**Board of Zoning Appeals Meeting
June 20, 2023**

CASE NUMBER:	V-23-0008
PROPERTY LOCATION:	820 Lake Medlock Drive, Johns Creek, GA 30022
CURRENT ZONING:	CUP (Community Unit Plan District) Conditional
PARCEL SIZE:	0.301 Acres
PROPERTY OWNER:	Andrew Askinas and Cynthia Doan
VARIANCE REQUEST:	Encroachment into the 75-foot stream buffer to expand an existing deck and bring the existing house and walkway into compliance
STAFF RECOMMENDATION:	APPROVAL WITH CONDITIONS

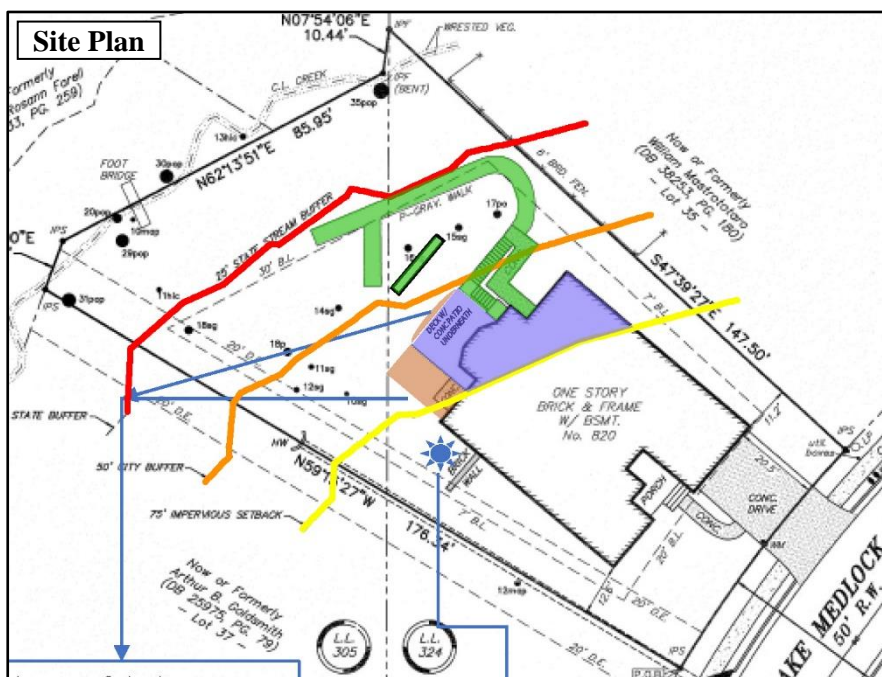
The Applicant is requesting to encroach 50 feet into the City's 75-foot stream buffer to expand an existing deck (highlighted in orange) and to bring the existing home (in blue) and walkway (in green) into compliance with the Stream Buffer Ordinance. The proposal will result in approximately 1,396 sq. ft. of impervious surface in the City's stream buffer. However, the net increase of impervious surface in the stream buffer would only be 126 sq. ft., as the house and walkway is already existing within the stream buffer.

The Applicant has not proposed any new land disturbance within the City's 50-foot undisturbed buffer or the State's 25-foot stream buffer.

The Applicant has proposed to plant one dogwood and three azaleas next to the proposed deck to offset stormwater and environmental impacts associated with requested encroachment into the stream buffer.

- 1) The proposed development shall not exceed the following encroachments, as shown on the site plan received by the Community Development Department on May 9, 2023:
 - a. 50 linear feet of encroachment into the City's stream buffer
 - b. 1,396 square feet of total impervious surface within the stream buffer
 - c. 126 square feet of new impervious surface within the stream buffer associated with the deck expansion

- 2) A vegetative planting plan shall be submitted to the Community Development Department for approval by the Deputy Director, prior to the issuance of a building permit. Said plan shall be consistent with the mitigation plan received by the Community Development Department on May 9, 2023. The final vegetative planting shall pass City inspection prior to the issuance of a Certificate of Completion for the deck.
